HOUSTON LIGHTING AND POWER COMPANY  
SOUTH TEXAS PROJECT ELECTRIC GENERATING STATION UNIT ONE  
LICENSE NO. NPF-76

SEMIANNUAL RADIOACTIVE EFFLUENT RELEASE REPORT

MARCH 8, THROUGH JUNE 30, 1988

FIELD CHANGE REQUEST  
CONTINUATION SHEET

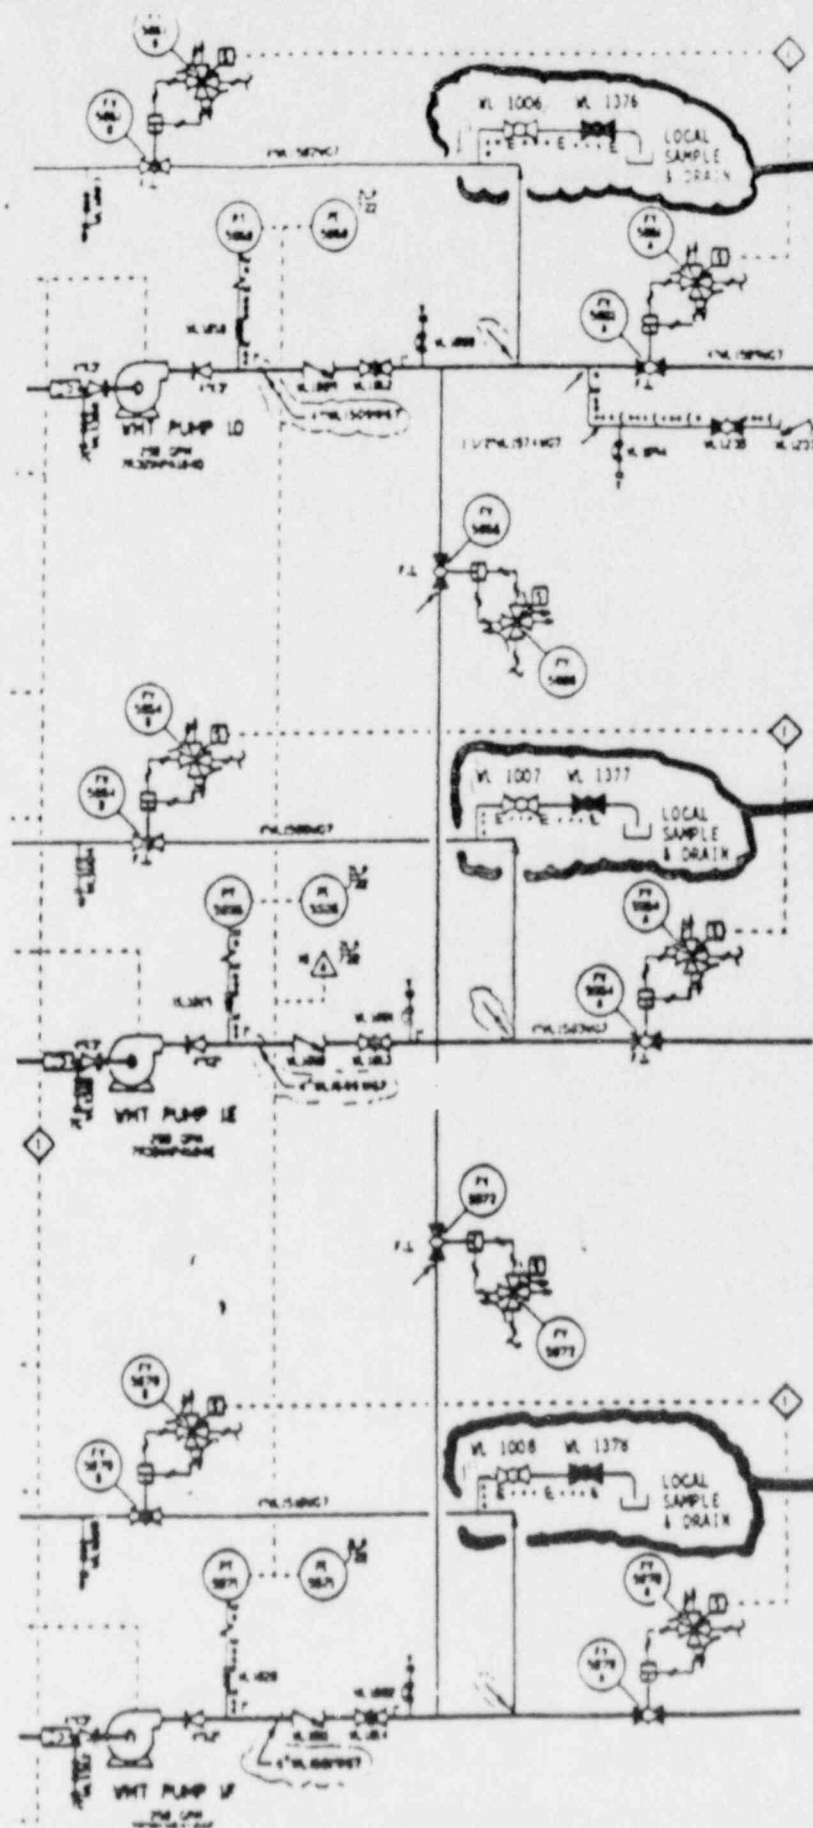
**AFTER**

**THIS  
FCR**

**THIS  
FCR**

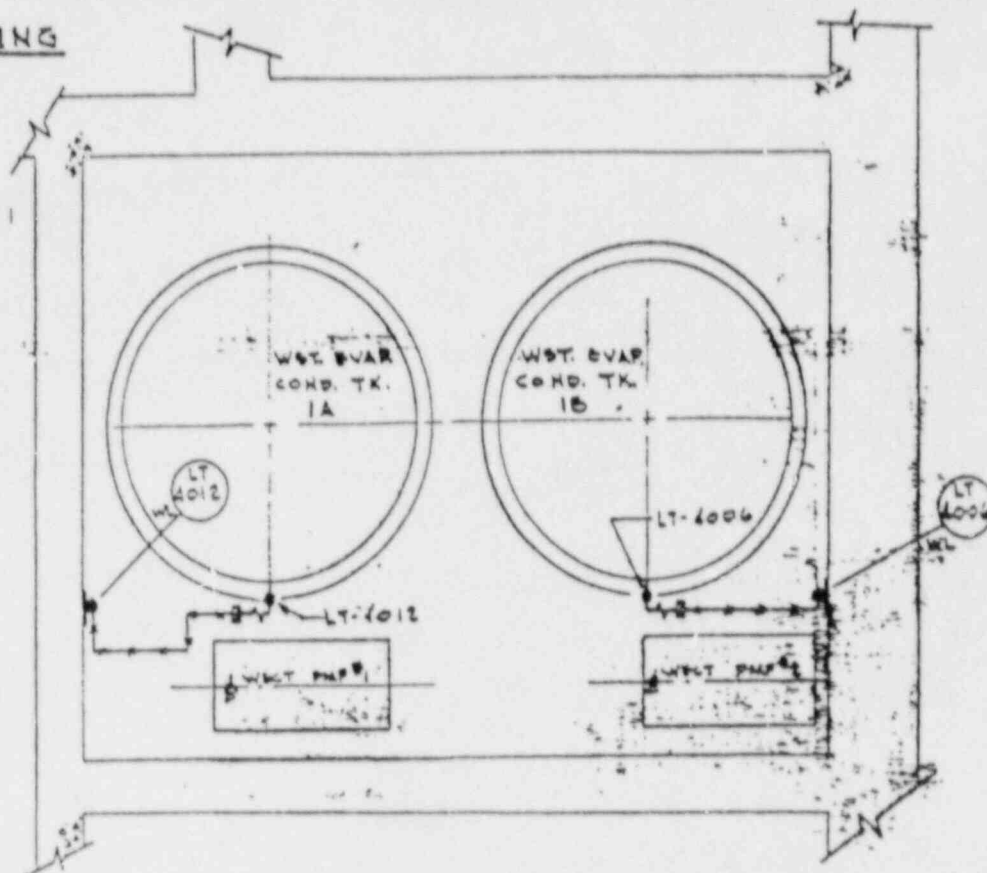
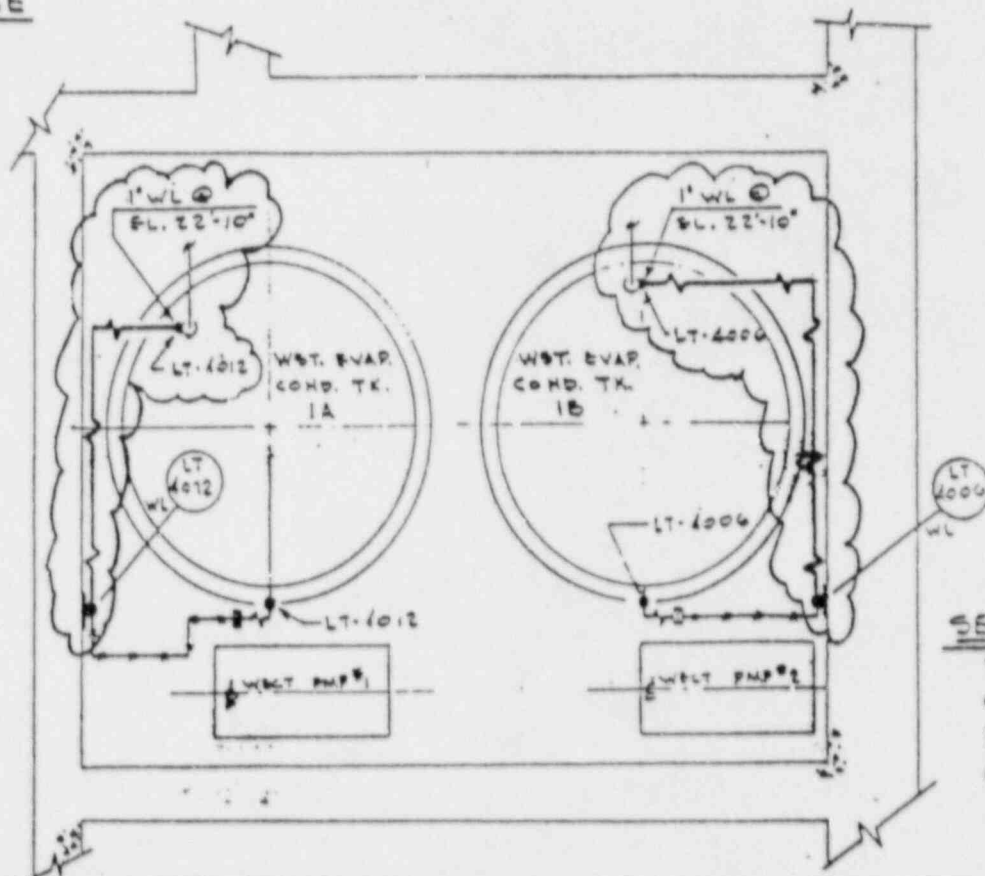
EXISTING

CHANGE

SEE NOTE  
SOME INFO  
OMITTED  
FOR  
CLARITY

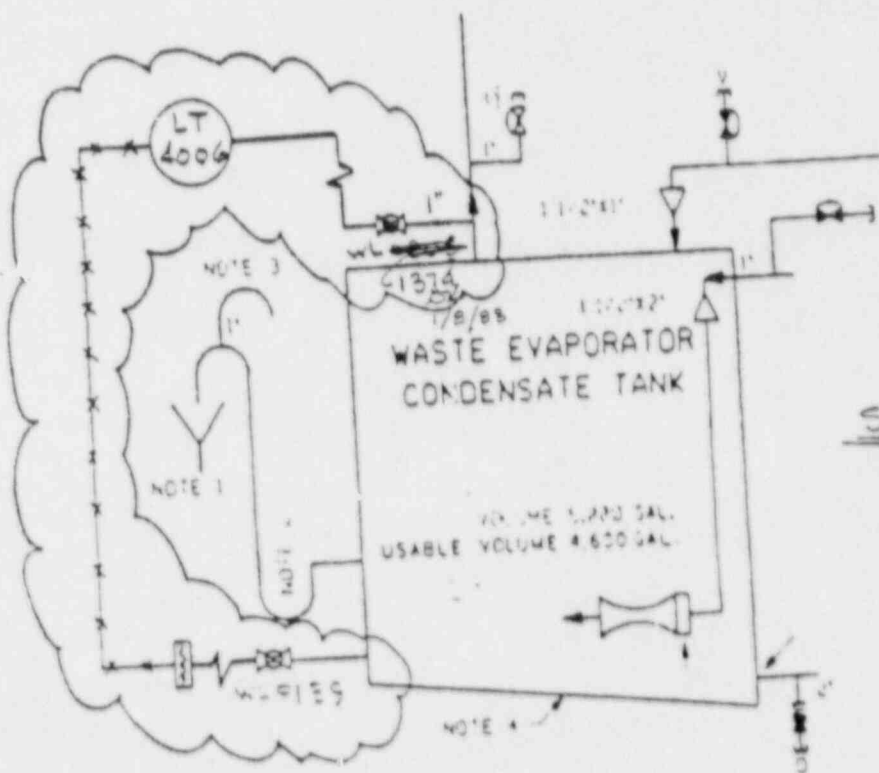
EXISTING

CHANGE

SEO-NOTE  
SOME  
INFO OMITTED  
FOR CLARITY

FIELD CHANGE REQUEST  
CONTINUATION SHEET

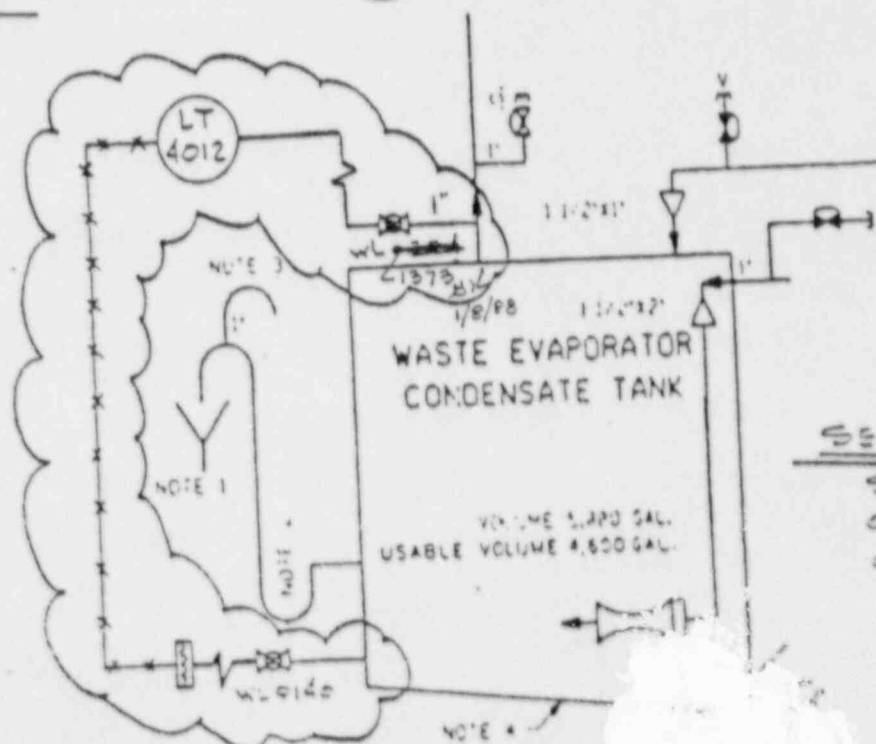
EXISTING

## CHANGE

SOME INFO  
OMITTED FOR  
CLARITY

DCN CONV.			
DATE:			
DRAWING NUMBER	SHEET NO.	REV. NO.	DCN NO.
7R 309F 900171		6

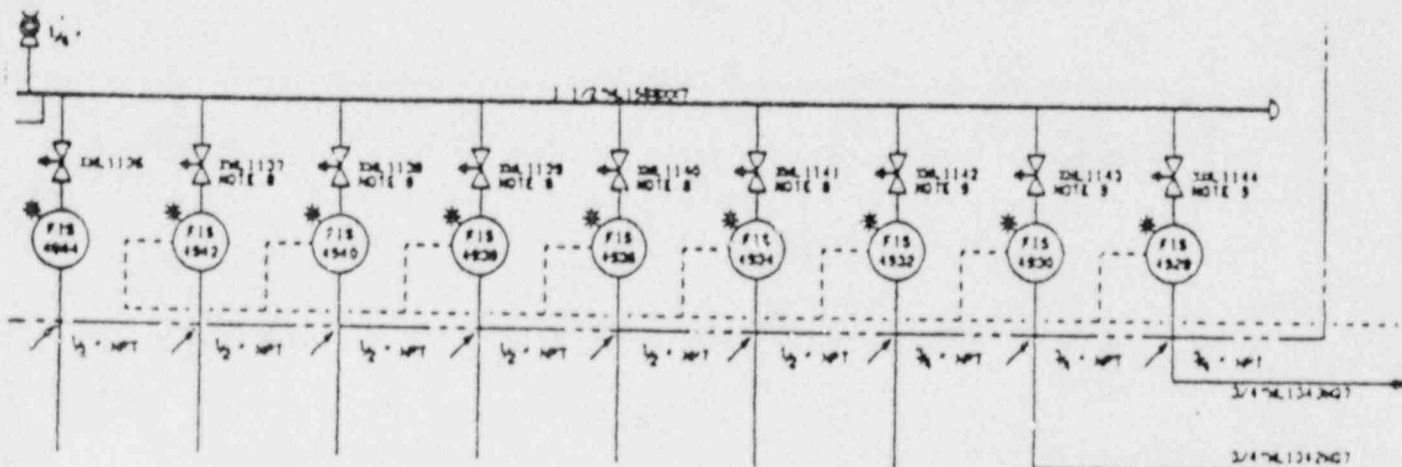
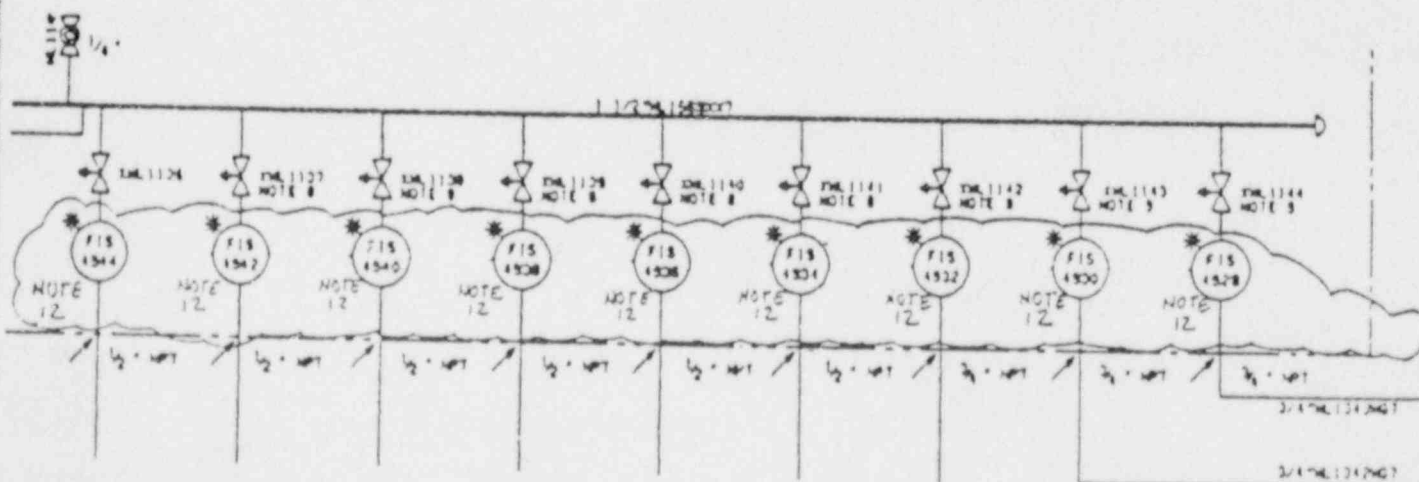
## DESCRIPTION OF CHANGE:

BEFORE:AFTER:

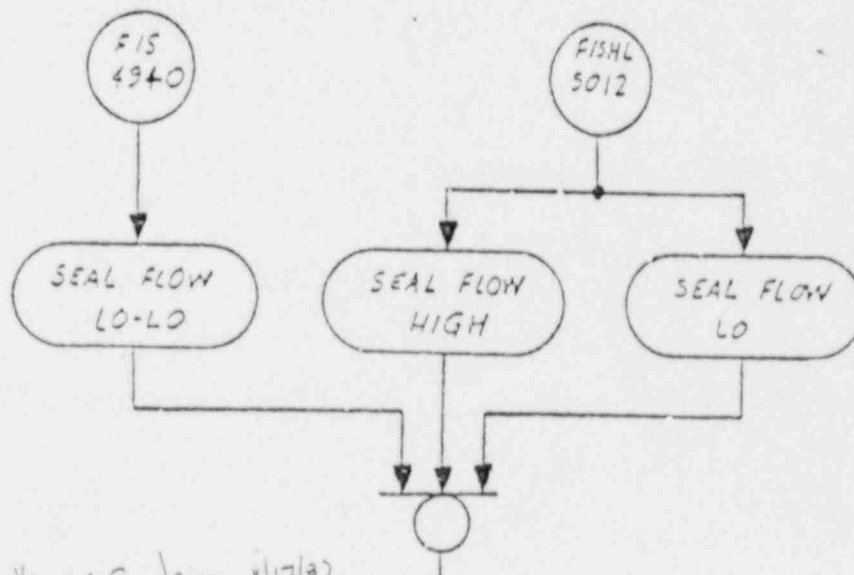
IDCN NUMBER \_\_\_\_\_ ISSUED DATE \_\_\_\_\_  
STARTUP SYSTEMS AFFECTED: W405JOB NO. 14926 PAGE 1 OF 2FSAR CHANGE REQUIRED? YES ☐ NO ☒REASON FOR CHANGE (Please be specific) NUISANCE ALARMS  
GENERATED BY SKID MOUNTED PRESSURE & FLOW SWITCHES.  
(REF. CARRS 1358 & 1595.)

## DESCRIPTION OF CHANGE

BEFORE:O Vincent C. Jones 11/17/87  
REV HL&P DATE  
14926-001

DCN CONV.			
DATE:			
DRAWING NUMBER	SHEET NO.	REV. NO.	DCN NO.
6R309Z4Z252		2

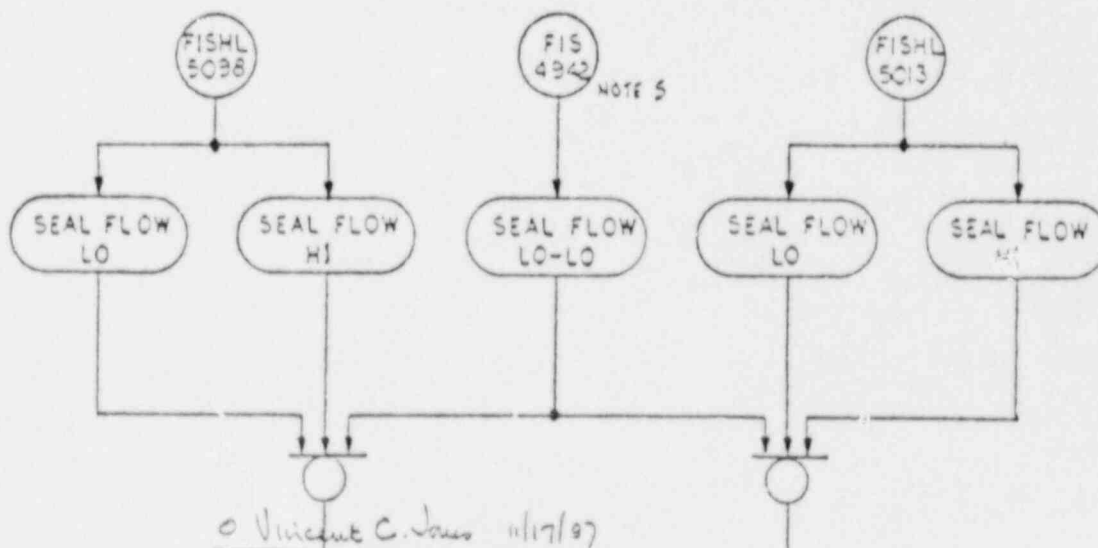
REASON FOR CHANGE (Please be specific) NUISANCE ALARMS  
GENERATED BY SKID MOUNTED PRESSURE AND FLOW SWITCHES.  
(REF. CARRS 1358 & 1595).

## DESCRIPTION OF CHANGE

BEFORE:

DRAWING NUMBER			DCN COM. DATE:		
SHEET NO.			REV. NO.		
DUC. REV.			DCN NO.		
6R309242253			2

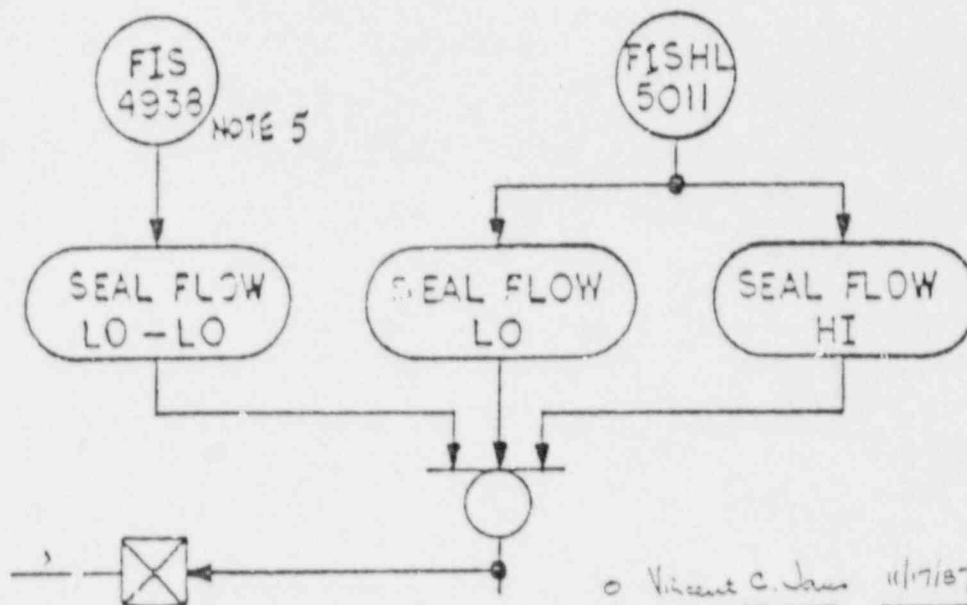
REASON FOR CHANGE (Please be specific) NUISANCE ALARMS  
GENERATED BY SKID MOUNTED PRESSURE AND FLOW SWITCHES.  
(REF. CARRS 1358 & 1595).

## DESCRIPTION OF CHANGE

BEFORE:

IDCN CONY.			
DATE:			
DRAWING NUMBER	SHEET NO.	REV. NO.	IDCN NO.
6R309242292		2

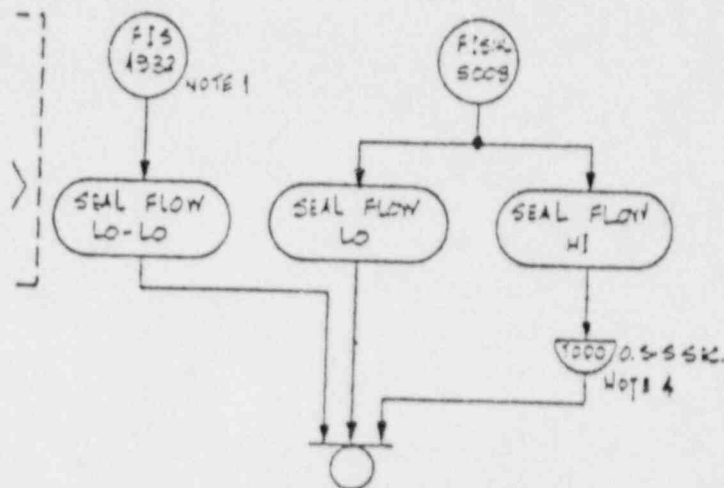
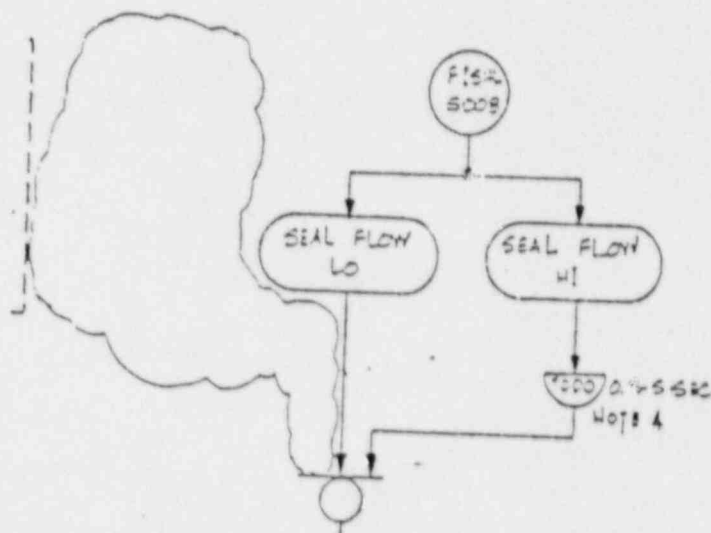
BEFORE:

AFTER:

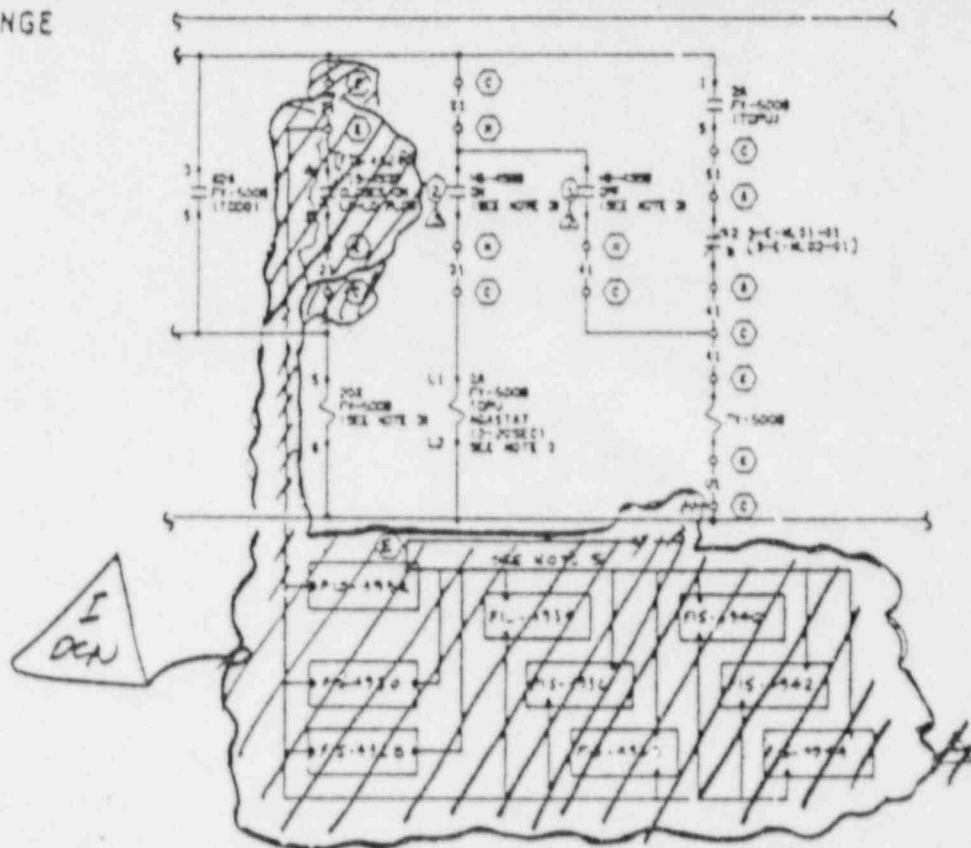
JOB NO. 14926 PAGE 1 OF 2STARTUP SYSTEMS AFFECTED: 1WL05FSAR CHANGE REQUIRED? YES ☐ NO ☒REASON FOR CHANGE (Please be specific) NUISANCE ALARMS  
GENERATED BY SKID MOUNTED PRESSURE AND  
FLOW SWITCHESREF. CORR # 1358 & 1595

DESCRIPTION OF CHANGE

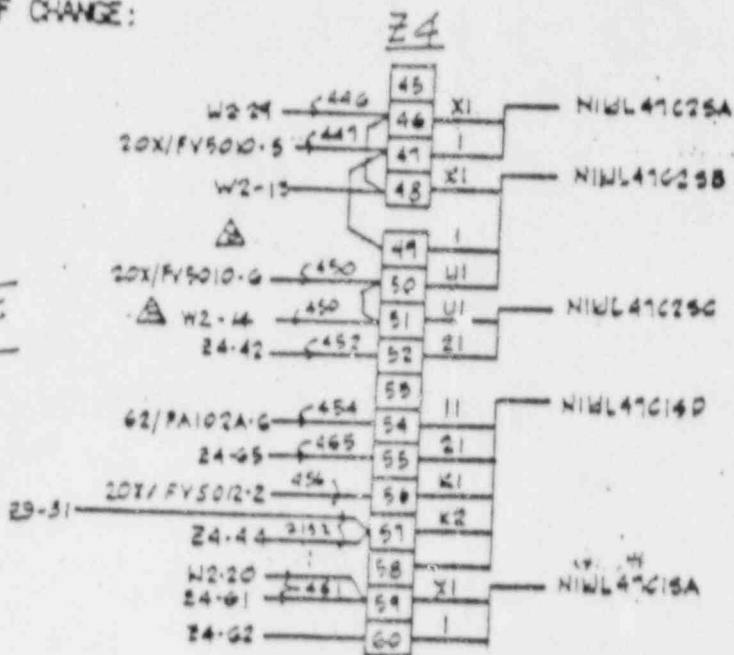
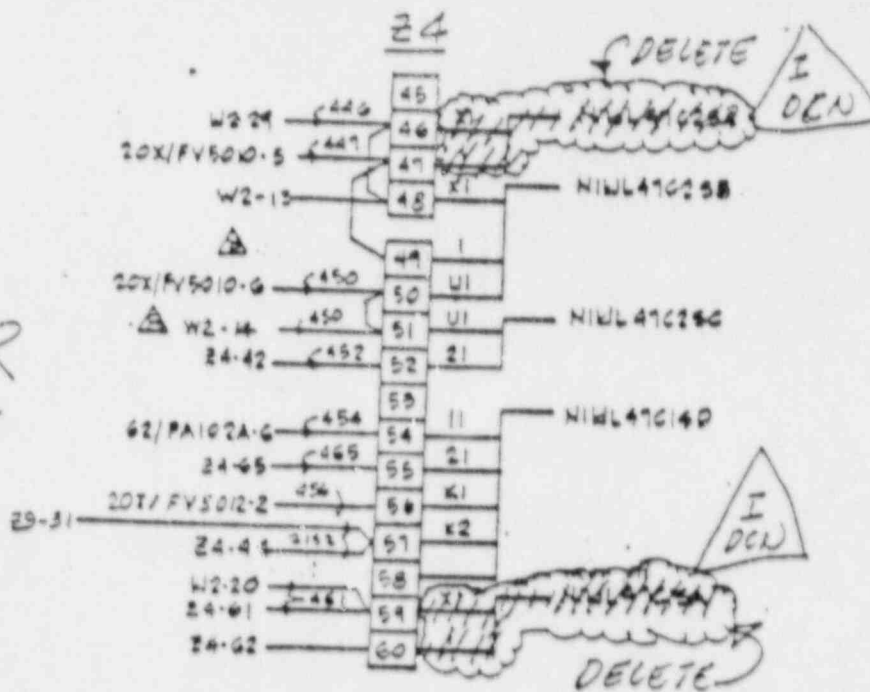
DESCRIPTION OF CHANGE:

BEFOREAFTER

DRAWING NUMBER		SHEET NO.	REV. NO.	DCM CONV.	
				DATE:	
				DAWG. REV.	DCM NO.
4089-00120-IC		-	D

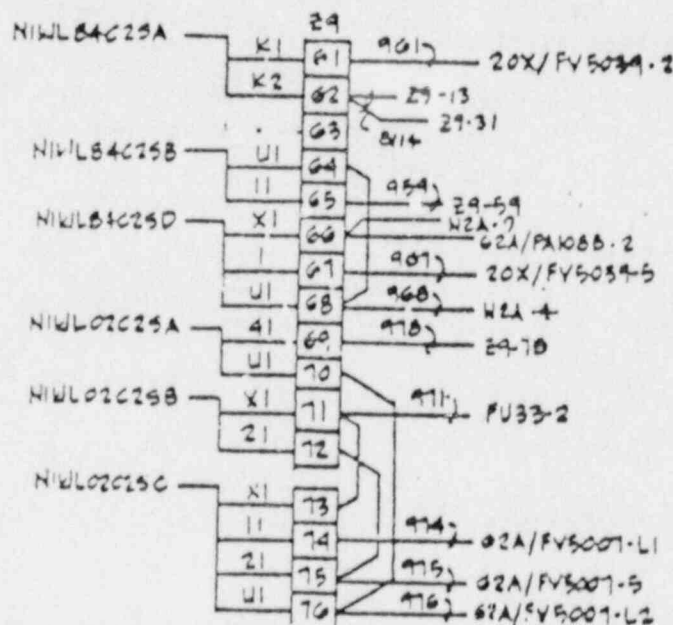
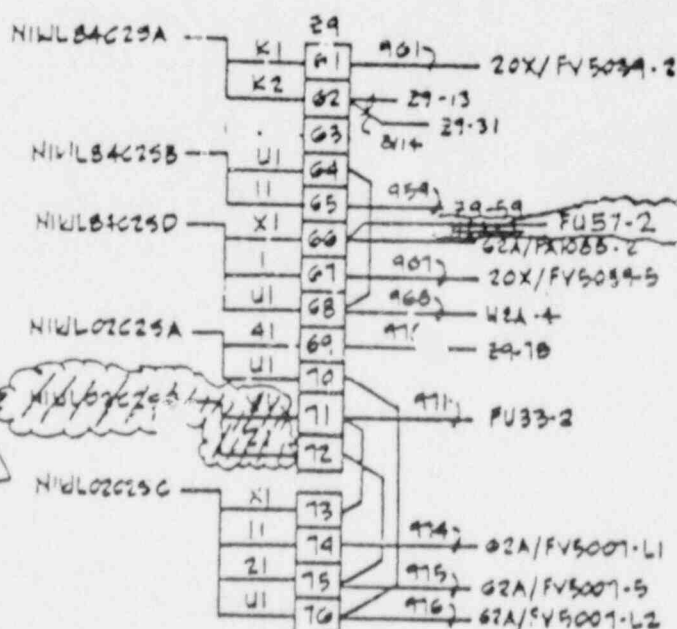
DESCRIPTION OF CHANGE:

BEFORE

AFTER

DELETE
